LINOTYPE IMPROVEMENT SHEET

No. 318

IMPROVED KNIFE WIPER ASSEMBLY

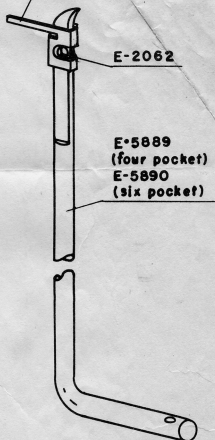
The new Wiper E-5888 is designed with flanges which securely grip the Knife Wiper Bar and prevent the Wiper from twisting, eliminating the need for the two E-4692 Pins formerly used. The new Knife Wiper is for use on both Four and Six Pocket Mold Disk machines.
